We request post-review adjustments on Table 1 of amt-2023-245. The terminology for the scattering correction factor was changed during the review process as required by Reviewer 2 (as shown by the snapshot of the response file shown below).

Point-by-point response to reviewers' comments (amt-2023-245)

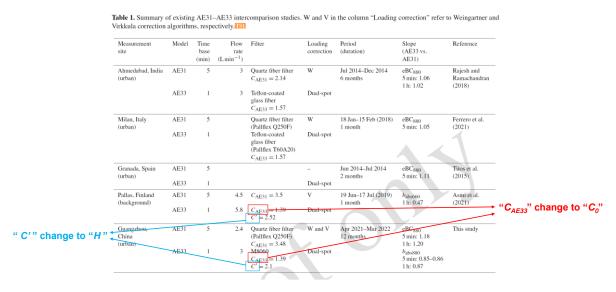
We applied the said changes in the main text and SI during the review process but forgot to update Table 1 accordingly. We spotted this issue during the proofreading. Therefore, we ask for adjustments to Table 1 as follows:

Response to R2Q3: Thanks for the suggestions. The use of C' had been abandoned and the second correction factor was termed as "harmonization factor" according to a previous study (Savadkoohi et al., 2023).

Equation (15) was revised as follows:

$$b_{abs} (AE33) = \frac{e^{BC_{corrected} \cdot \sigma_{air}}}{H}$$
 (15)
